PROFILE ALIGNMENT AND GRADE OF P.C. 5433
SANITARY SEWERS PAGE 1
J.N. 0352.82
TO BE CONSTRUCTED IN

TRACT Nº 25313

PRIVATE CONTRACT NO. 5433

P.C. 5433 PAGE 14

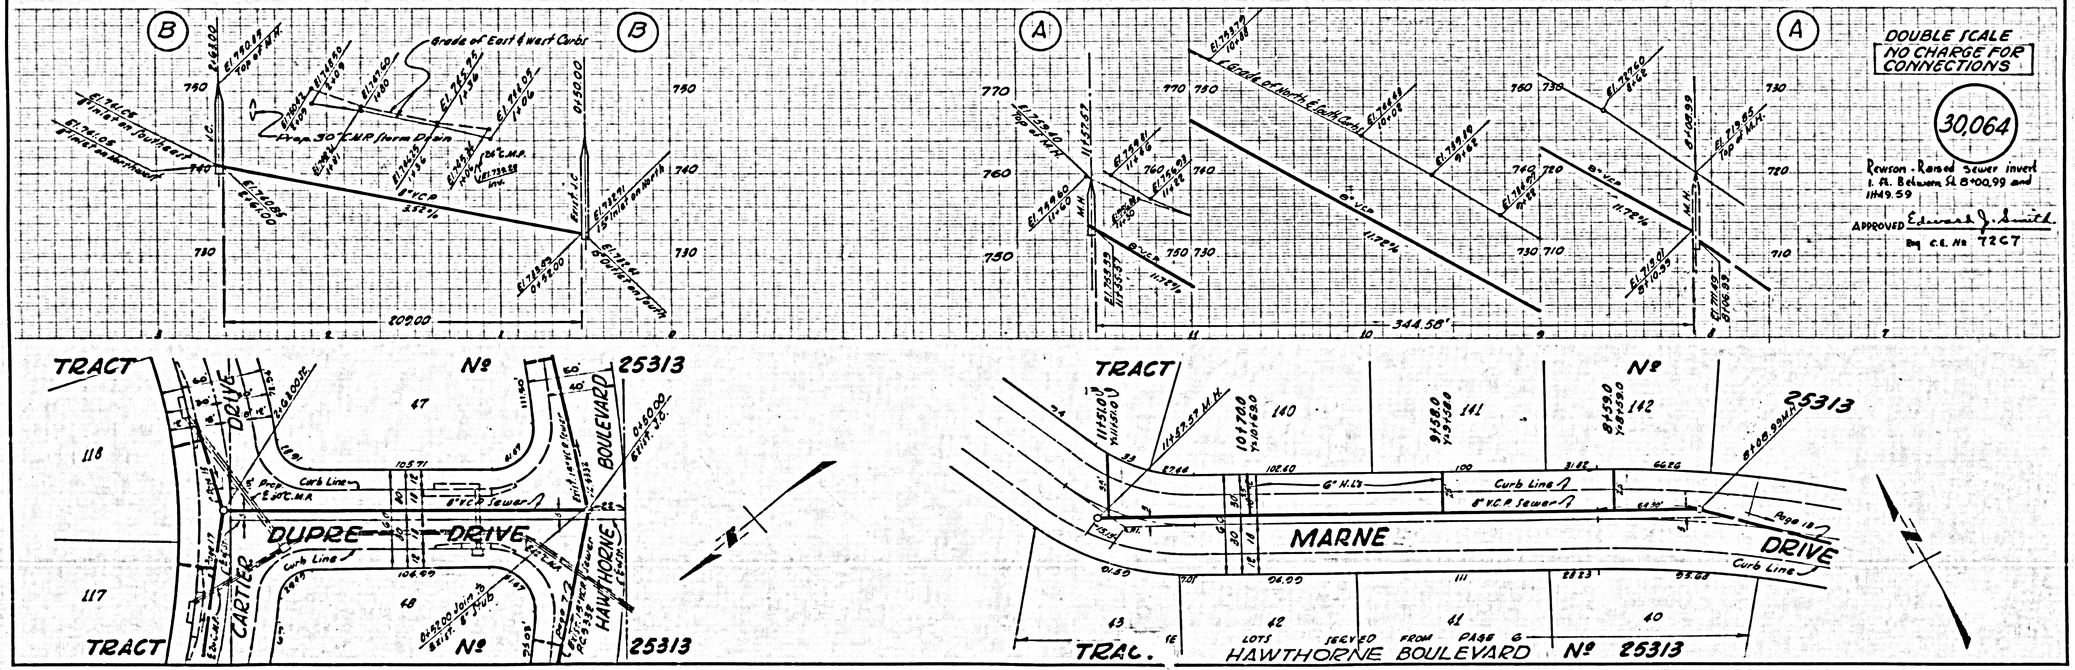
Rowson - Raised Sewer invert
I. A. Between St 8+00.99 and 11+49.59

APPROVED Edward J. Smith
By C.E. No 7267

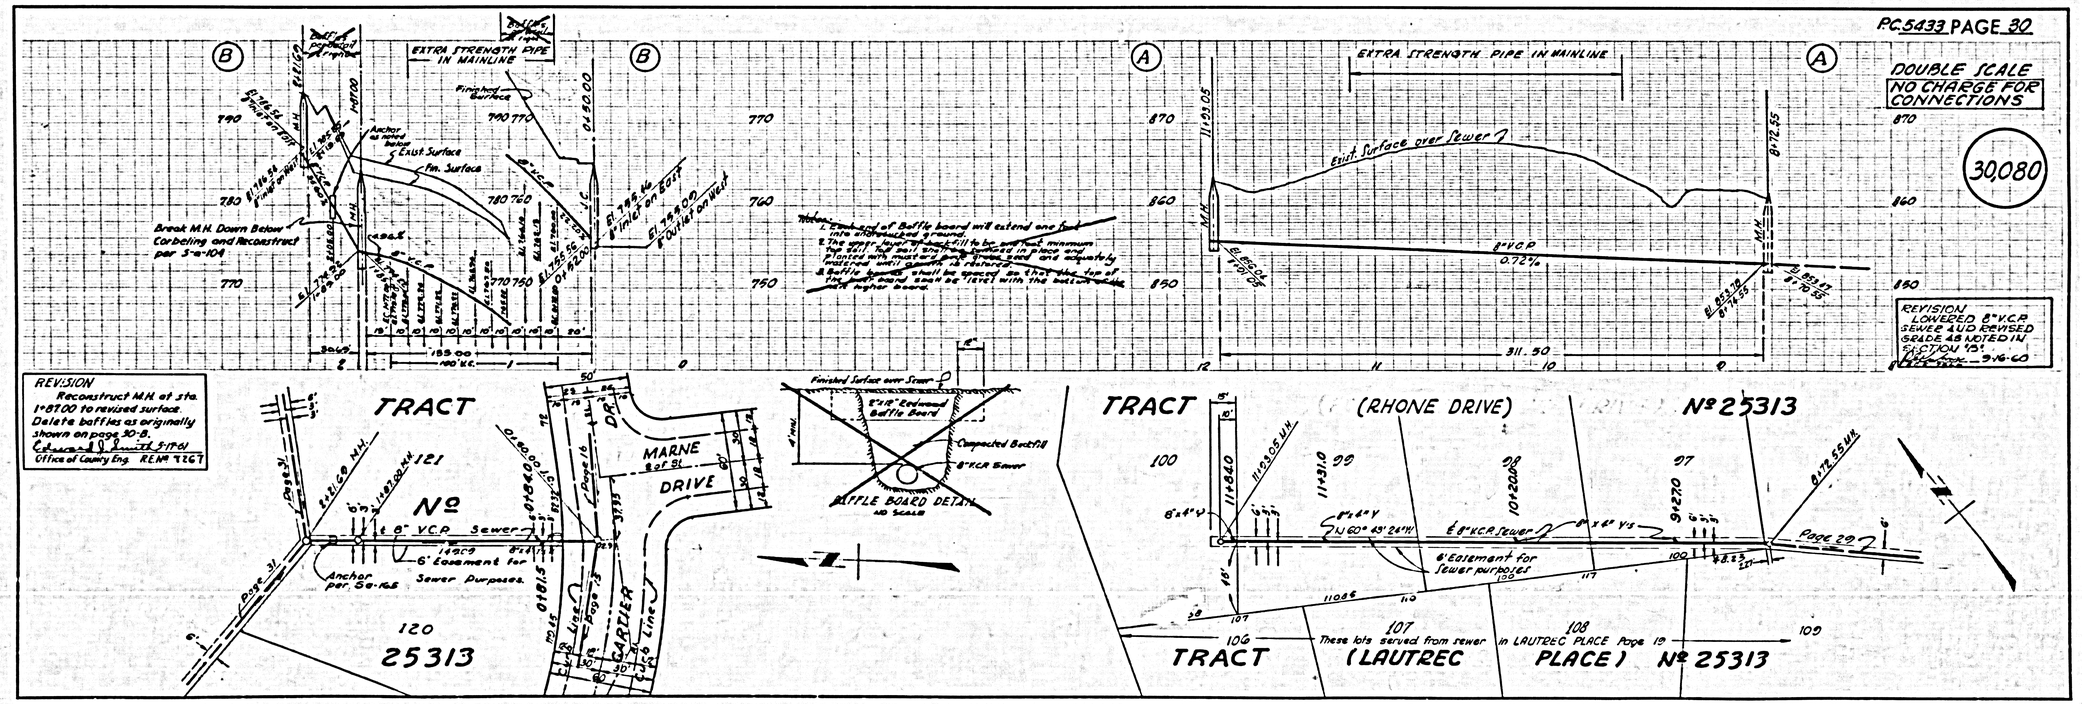
P.C.5433 PAGE 30
DOUBLE SCALE
NO CHARGE FOR CONNECTIONS
30,080
EXTRA STRENGTH PIPE IN MAINLINE
Exist. Surface over Sewer
8" V.C.P.
0.72%
311.50
REVISION
LOWERED 8" V.C.P. SEWER AND REVISED GRADE AS NOTED IN SECTION "B"
REVISION
Reconstruct M.H. at sta. 1+87.00 to revised surface. Delete baffles as originally shown on page 30-B.
Office of County Eng. R.E. Nº 7267
TRACT
Nº
25313
MARNE DRIVE
CARTIER
BAFFLE BOARD DETAIL
NO SCALE
Finished Surface over Sewer
Compacted Backfill
8" V.C.P. Sewer
6' Easement for Sewer Purposes
Anchor per Sa-165
TRACT (RHONE DRIVE) Nº 25313
TRACT (LAUTREC PLACE) Nº 25313
These lots served from sewer in LAUTREC PLACE Page 19
Page 29
